REVISION					
REV	DESCRIPTION	DRAWN	APPR	DATE	
1 R	Initial Registration			1998.05.25.	
1	특성 개선 (내부 형태 변경)	Y.H.SON	B.H.AN	2004.06.01.	
2	[설변201409-0008] 신뢰성 향상 (특성값 기준 변경)	E.H.KIM	I.C.KIM	2014.09.23.

TOLERANCE	Decimal	DATE			 RF & MICROWAVE TECHNOLOGY Tel : 82-32-347-8015 Fax : 82-32-347-8017	
	±0.2	2014. 09. 23.				
	Angle	APPROVED BY		I.C.KIM		
		CHECKED BY				
MATERIAL		DRAWN BY		TITLE		
-		E.H.KIM		N50 (J) N50 (J) BH ADAPTOR		
FINISH		SCALE	UNIT	 A4	DWG NO.	
-		2/1	mm		AD00102-7/2	
				REVISION	SHEET	
				2	1 of 1

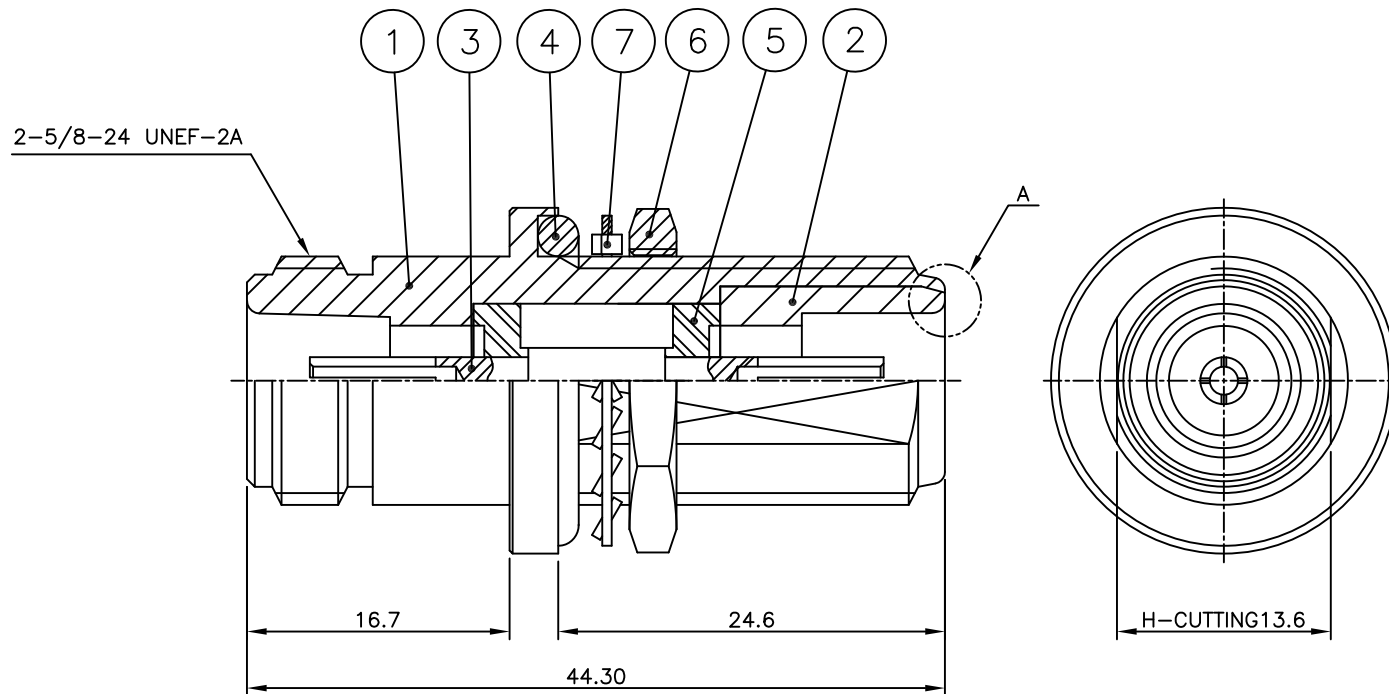
△₂ V.S.W.R : ~~1.2 max~~ 1.25 max

△₂ Insertion Loss : ~~-0.12 min~~ -0.3dB min
